Memo

To: Planning Board Chairperson Pearson and Secretary Carpinelli
From: Plan Review Committee of the Verona Environmental Commission
c: Verona Environmental Commission Chair
Date: March 6, 2026
Re: **Case # 2026-01**
383 Bloomfield Avenue [Block 708, Lot 1]
Verona, New Jersey
Zone: ETC (Extended Town Center/Zoning Redevelopment Plan)

Figure 1: USDA NRCS Web Soil Survey Map of Site

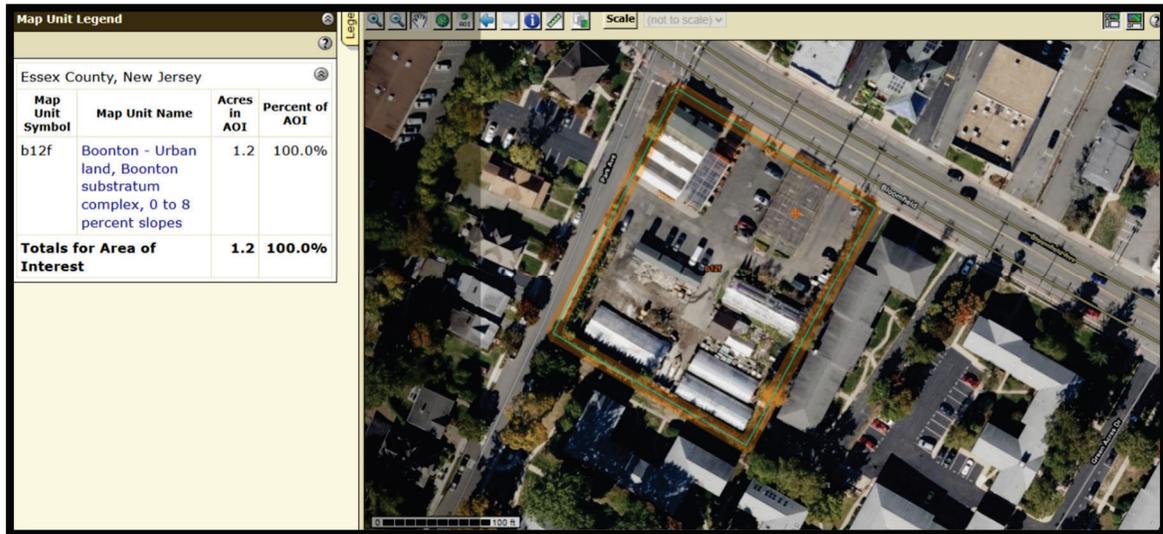
Figure 1 below depicts the Web Soil Survey of the site, while Figure 2 shows a similar soil profile as found in the Soil Data Report, affirming that the drainage class of the soil is “well drained.”
